Mask Set Errata for Mask 2L71Y

This mask set errata applies to the mask 2L71Y for these products:

- MC9S08RE16
- MC9S08RE8
- MC9S08RD16
- MC9S08RD8
- MC9S08RC16
- MC9S08RC8

Case 1

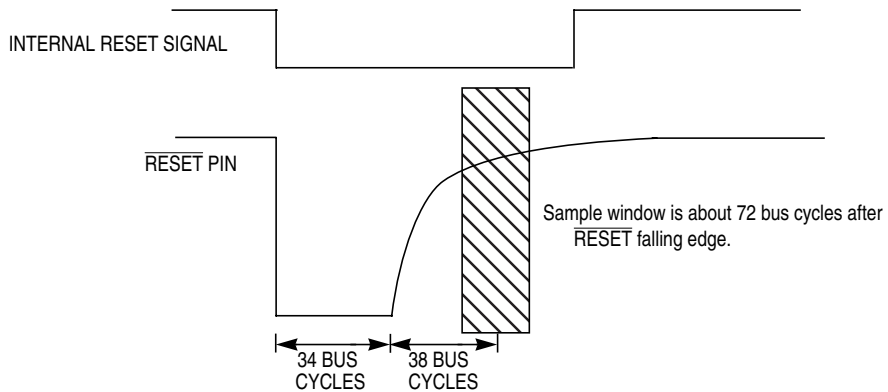
If a falling edge is detected on the external reset pin at either of two sample points, the MCU will cease operation and will recover only after a power-on reset.

Case 1 — After detecting a reset signal, either internal or external, the internal reset circuit latches the cause of the reset, forces a low level on the external $\overline{\text{RESET}}$ pin for about 34 bus cycles, releases the pin, and samples the pin level about 38 bus cycles later.

To avoid multiple edges on the $\overline{\text{RESET}}$ pin due to switch contact ringing or EMC noise, eliminate any voltage bounce through RC filtering. A 0.1 μF capacitor to ground and an external 4.7 k Ω to 10 k Ω resistor to V_{DD} works well to ensure noise suppression.

Case 2

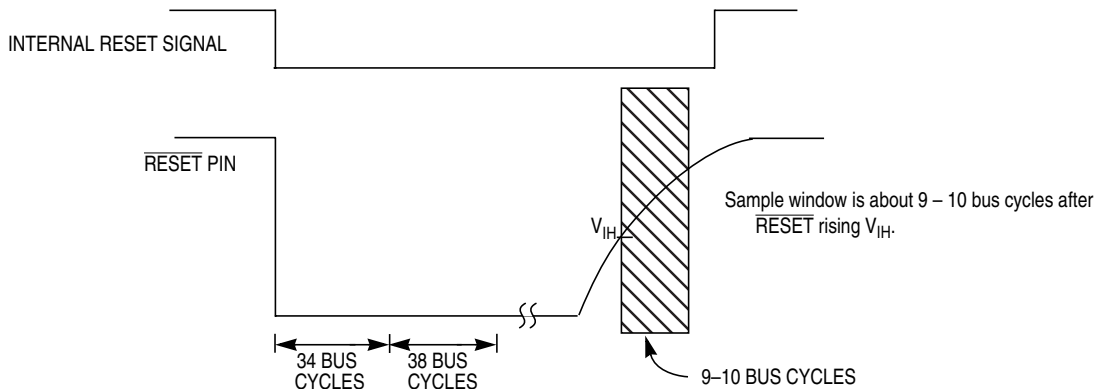
Case 2 — After remaining in reset for an extended period of time due to an externally applied low level on $\overline{\text{RESET}}$, the internal reset circuit will sample the pin level about 9 to 10 bus cycles after the pin raises above its V_{IH} level.

In addition to RC filtering, avoid spurious edges on the $\overline{\text{RESET}}$ pin caused by external active circuitry such as low voltage detectors and watchdog components. Do this by ensuring that external circuitry cannot drive $\overline{\text{RESET}}$ low within 10 bus cycles of the release of $\overline{\text{RESET}}$.
